HISTORIC LANDMARK COMMISSION
JANUARY 23, 2012
CERTIFICATE OF APPROPRIATENESS
LHD-2011-0026
4107 Avenue G
Hyde Park Local Historic District

Construct a new 2,868 sq. ft. single-family residence with garage on vacant lot.

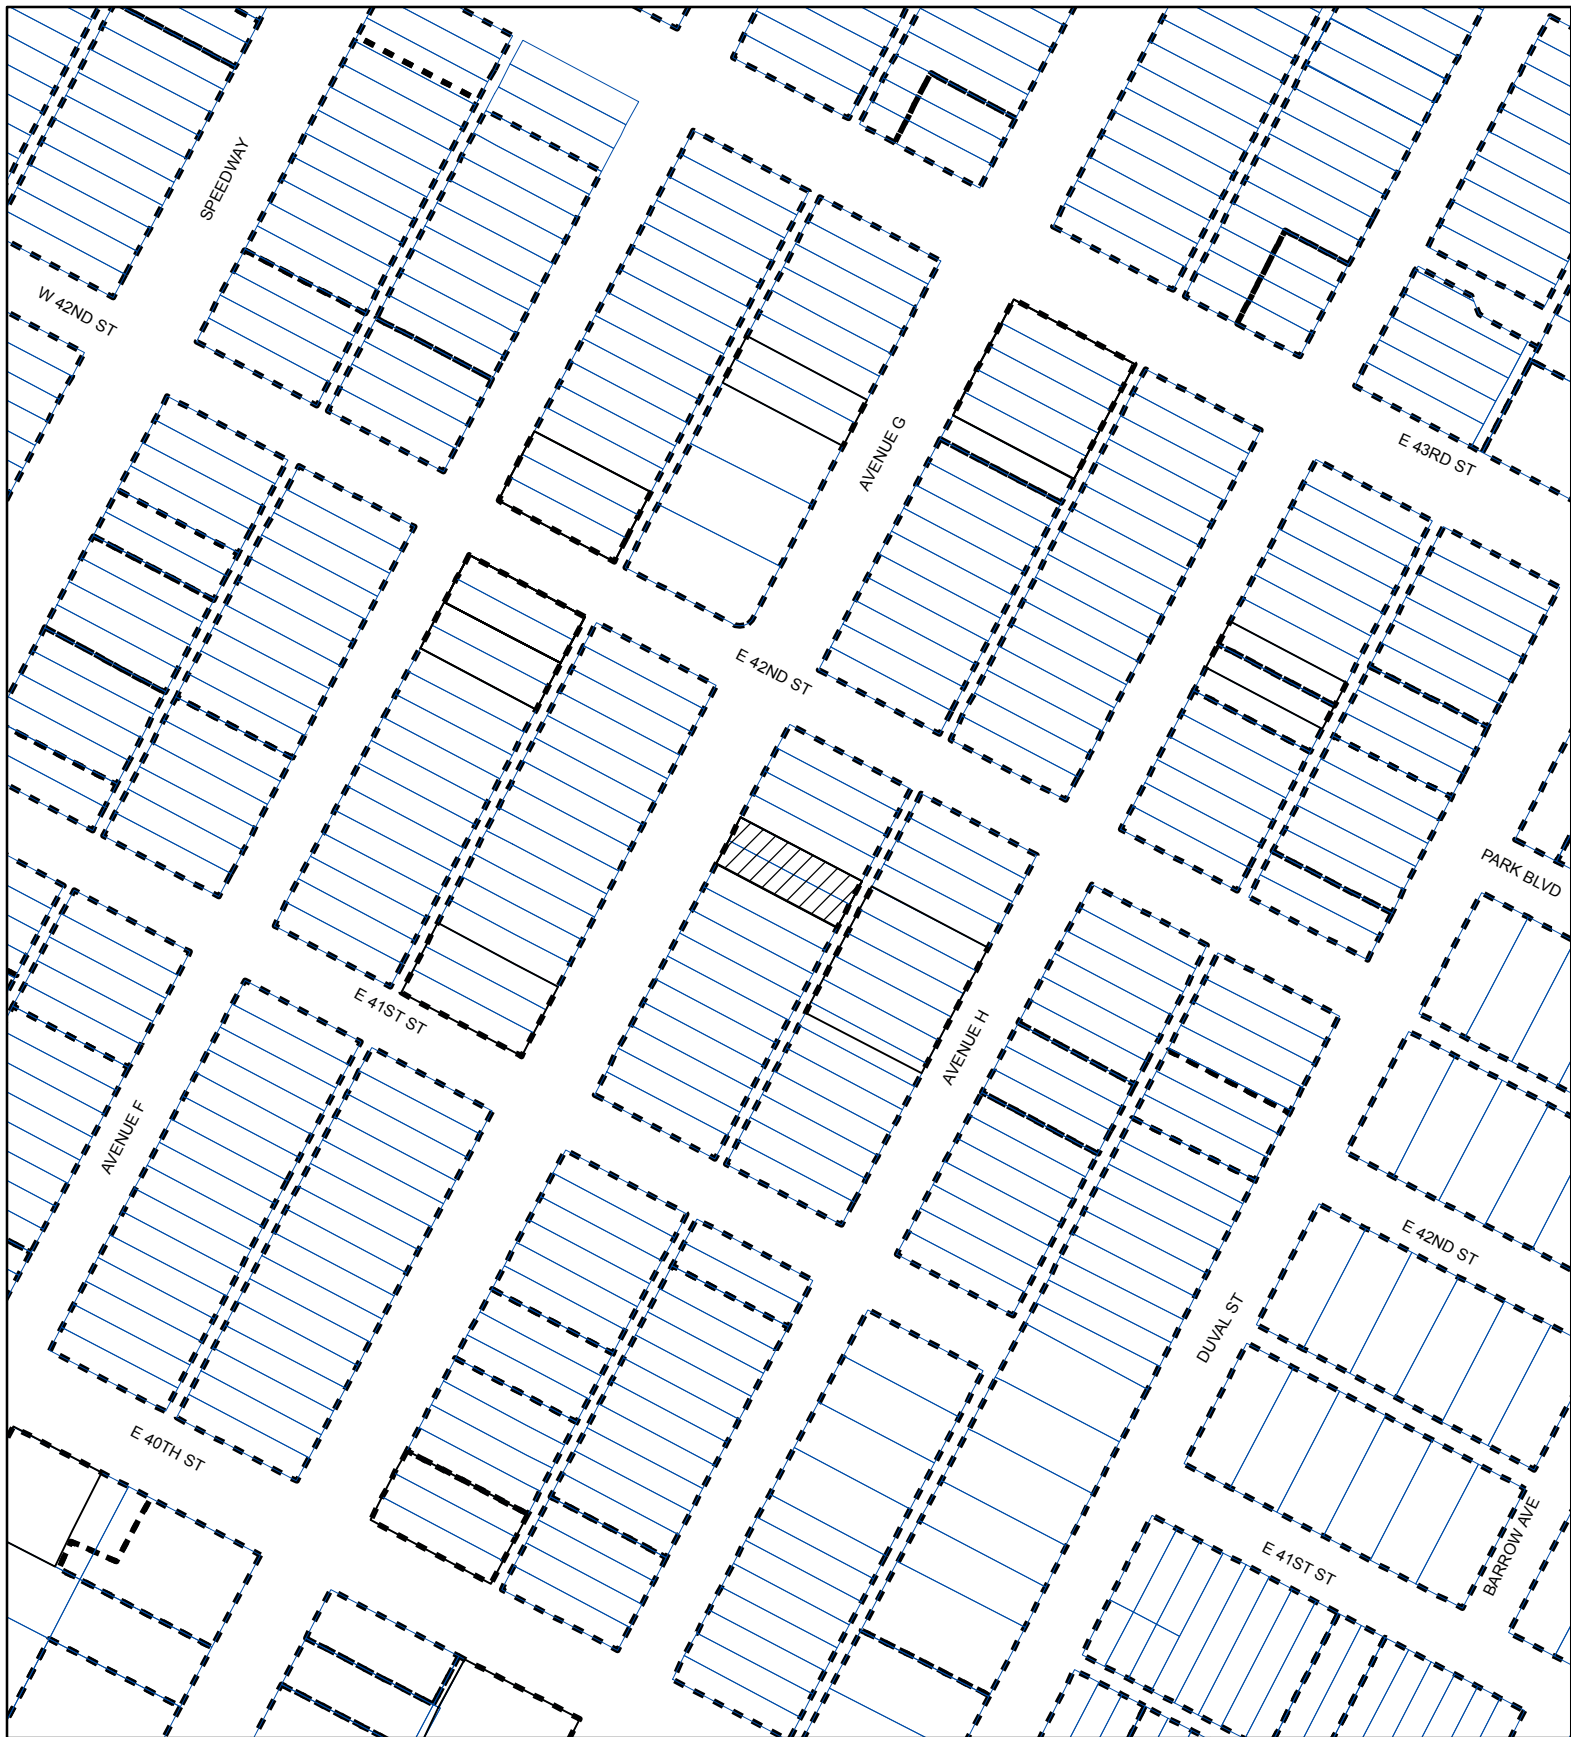
Use thin stone veneer on porch columns and chimney, and shingles in the front gable ends to differentiate the house from historic homes. Provide a more molded or crafted detail to the front porch railing.
